21st January 2022

Our Ref: 21-367

Your Ref: DA2021/53

Addendum: Erection of a 4.95MW Solar Farm at Wathagar, 2910 Gwydir Highway Moree NSW 2400 (Lot 2 in DP773266)

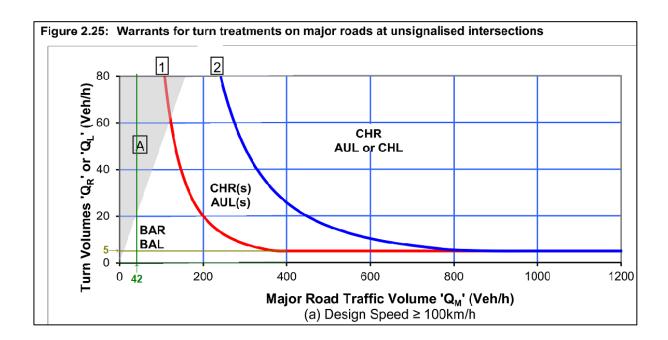
Figure 2.25 below shows the warrants for different intersection types. A vertical line for Major Road Traffic Volume at 42 vehicles/hour has been added (maximum on record). A horizontal line has been added at 5 vehicles. Any intersection with an hourly turning volume less than this value is considered suitable for a BAR BAL intersection.

Due to the low turning volume (3-4 vehicles per hour total), as well as the low major road volume, an assessment of figure 2.25 indicates that the intersection requires a BAR and BAL treatment.
